Highway Development Control Consultation Response

Planning Application Ref: PL/2026/01336

Site Address: Oakley Farm, Bullocks Horn, Charlton, Malmesbury, SN16 9DZ.

Proposal: Construction of a new agricultural field entrance with a 12 ft (3.66 m) timber gate set 4.5 m back from the highway boundary.

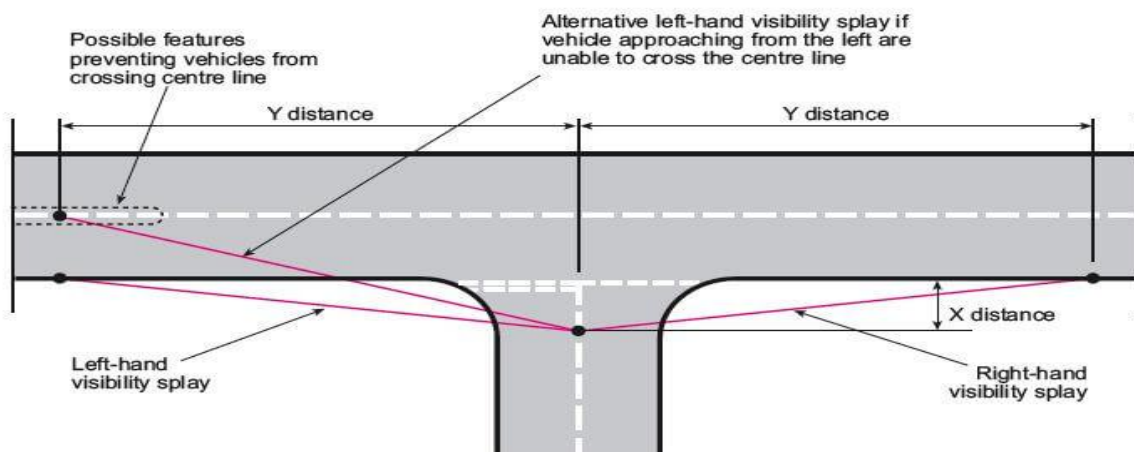
It is still required to provide a correct demonstration of the visibility splays achieved at the access; this should be a plan to scale and show the extent of the required splay. The plan provided is not to scale and does not demonstrate visibility onto Bullocks Horn Lane as would be expected to satisfy that the required or improved splay is achievable.

I attach an extract of how this should be demonstrated on a scale plan:

If the visibility splay can be demonstrated as per required standards on a plan to scale then I will be in a position to make any recommendations with regard to conditions and informatives.
